Lewis Road PRD
Response to Central Pine Barrens Commission Draft Staff Report
Dated August 19, 2020

Prepared by: Nelson Pope Voorhis
70 Maxess Road
Melville, NY 11747

Prepared for: Discovery Land Company
14605 N 73rd Street
Scottsdale, AZ 85260

Date: August 19, 2020

1984 Aerial Photograph of Town Dump Site (Suffolk County GIS)

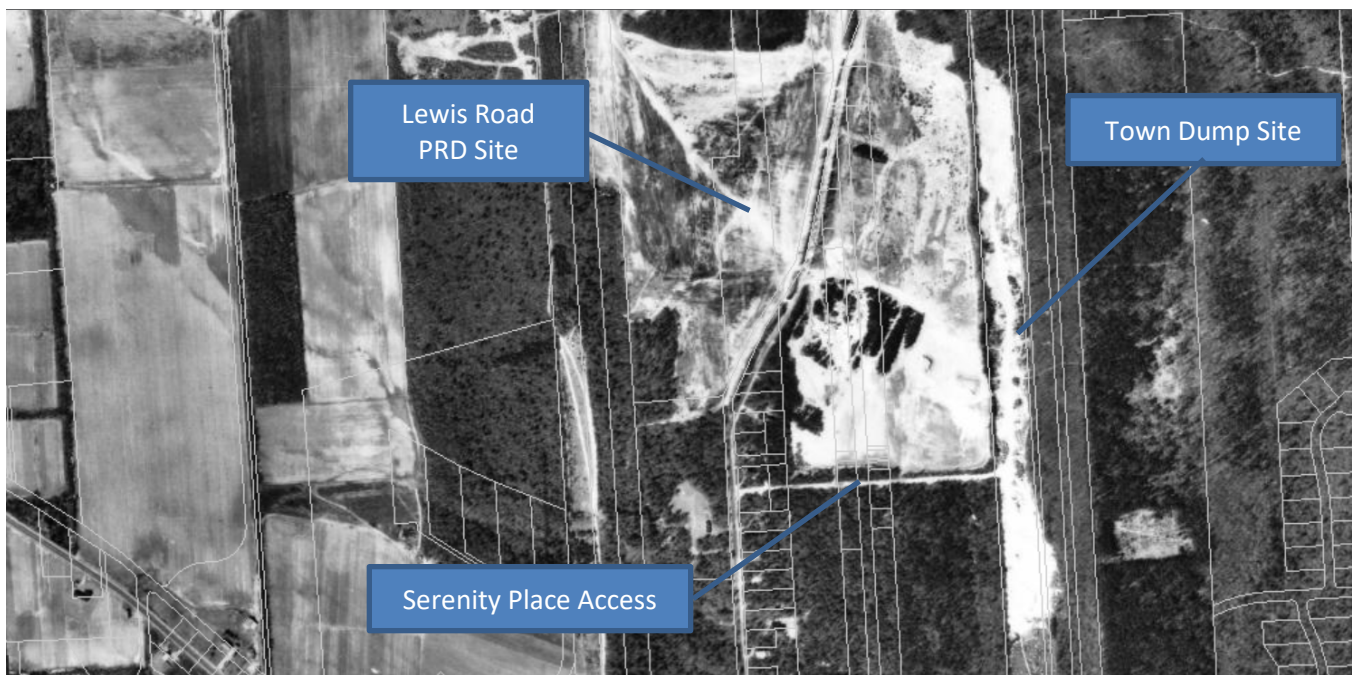
- ***The Commission must determine whether the Project conforms to this Guideline.***
This Guideline refers to “Established recreational and educational trails and trail corridors.” The Draft Staff Report makes note of existing hiking trails on the public land to the east. The context of the Town land east of the site should be understood. This land was used by the Town as a leaf and clearing debris dumping area. Based on review of aerial photographs, the site was active from prior to 1962 until after 1984. The dump area was accessed through the Serenity Place tap road off of Spinney Road, and clearing in the Town land was extensive. Since that time, the location has grown over to some extent. Serenity Place had remained an active access point for dirt bikes and ATVs until just a few months ago. This trespassing occurred on the Lewis Road PRD property and the Town land, and a walk on the Town site will reveal that this use scarred the land and was uncontrolled until DLC cut off the access. Now this Town land has the potential to be used for future trail connections. Realistically, this land is not easily accessed and does not appear to be extensively used for hiking. Given the historic context as a dump site, and the recent impacts of unauthorized use, this land cannot be considered an established recreational or educational trail. As demonstrated in the EIS record and other submissions to the Commission, the development areas of the Lewis Road site are set back from roads and public places and are not visually significant.

The applicant commits to staking of clearing and grading limits as well as inspections to avoid disturbance, erosion or clearing off-site. As a result, the Commission has sufficient information to determine that the project complies with the Guideline.
